REFUELING OPERATION

3/4.9.9 WATER LEVEL - SPENT FUEL STORAGE POOL

BSEP SPENT FUEL POOL STORAGE EXPANSION

Analysis I.D. 80011-M-02-F

FIGURE 1

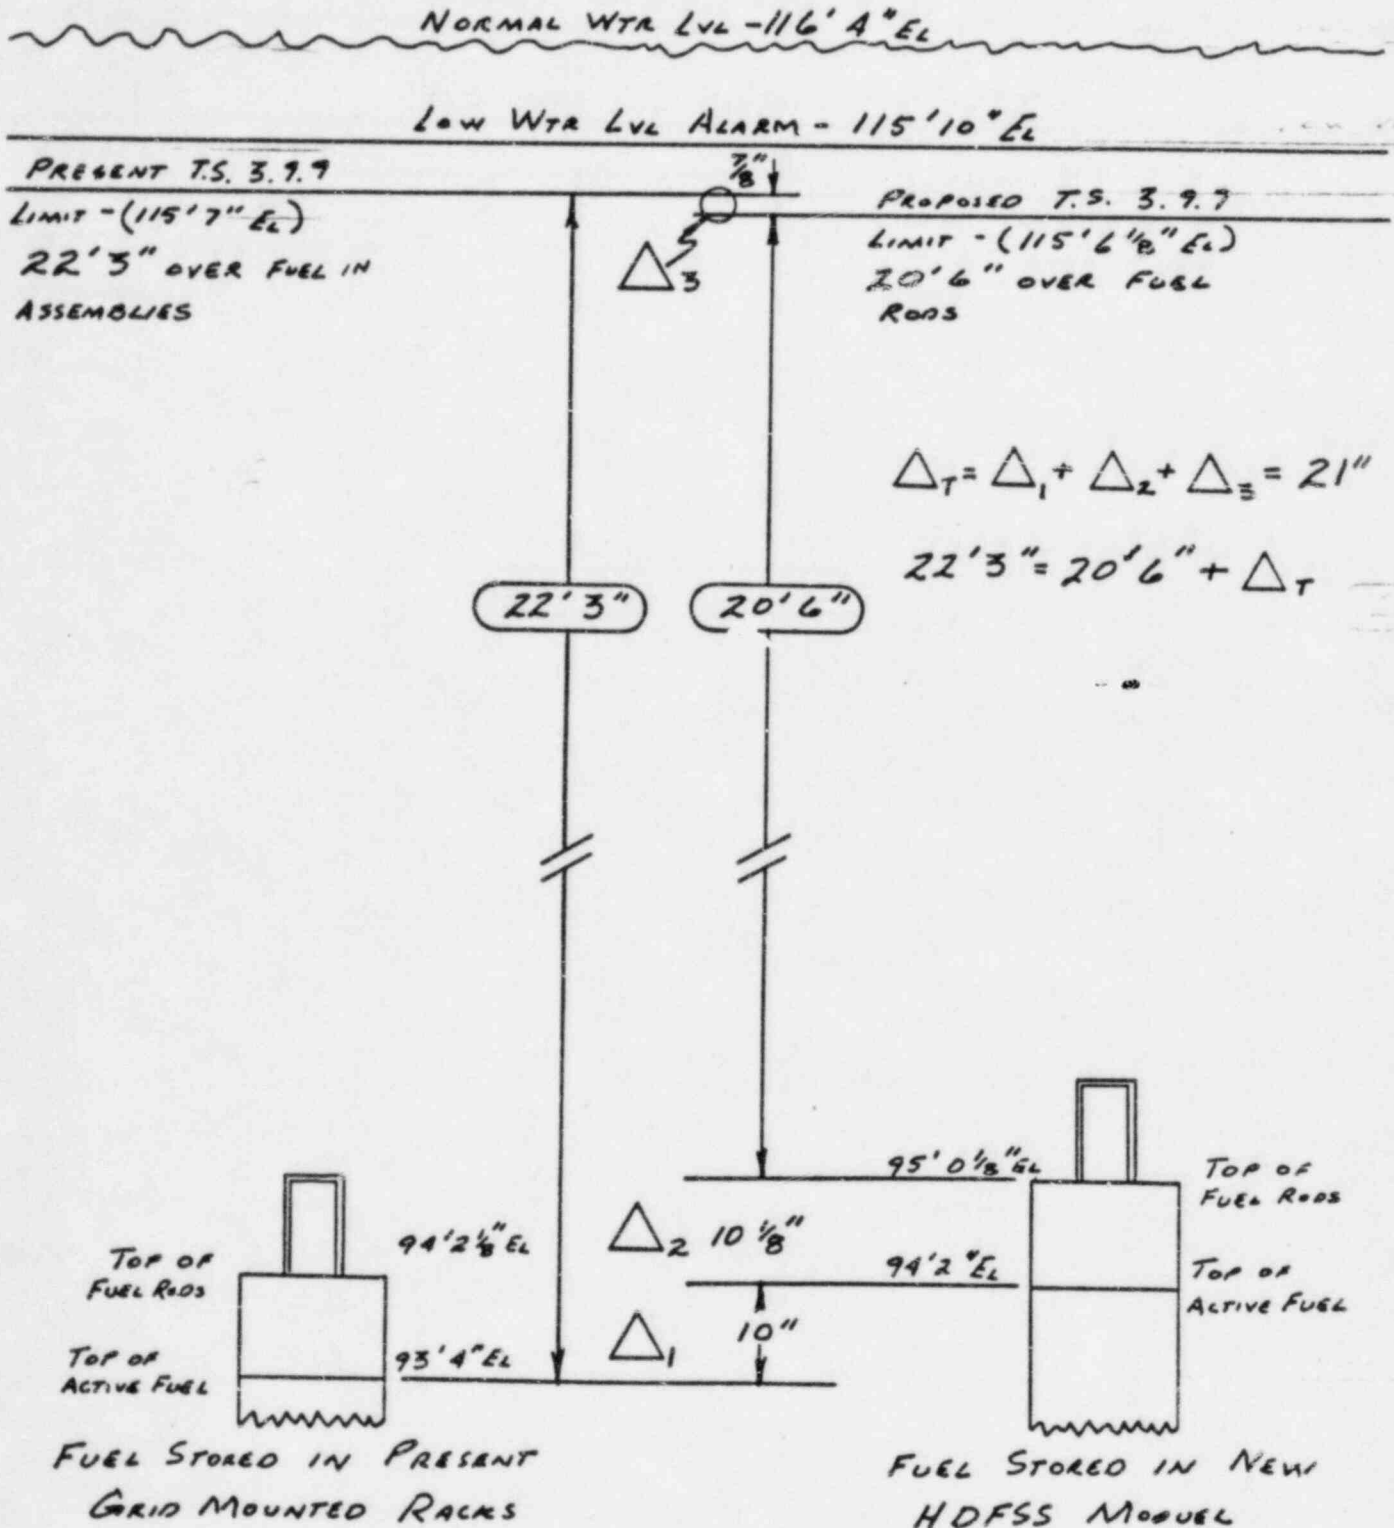
DEMONSTRATION OF NUMERICAL DIFFERENCE
IN WATER DEPTH BETWEEN NEW HDFSS
MODULES AND OLD GRID MOUNTED RACKS

NOTE: THIS INCLUDES BOTH A REDUCTION OF WATER DUE TO THE HIGHER HDFSS RACKS PLUS A CHANGE OF REFERENCE FROM TOP OF ACTIVE IRRADIATED FUEL ASSEMBLIES TO TOP OF FUEL ROOS.

7.2 THE BSEP TECH. SPEC. 3.9.9 CAN BE SAFELY REWORKED TO 20'6" OF WATER TO BE MAINTAINED OVER THE TOP OF THE FUEL RODS FOR FUEL STORED IN THE SPENT FUEL STORAGE RACKS.
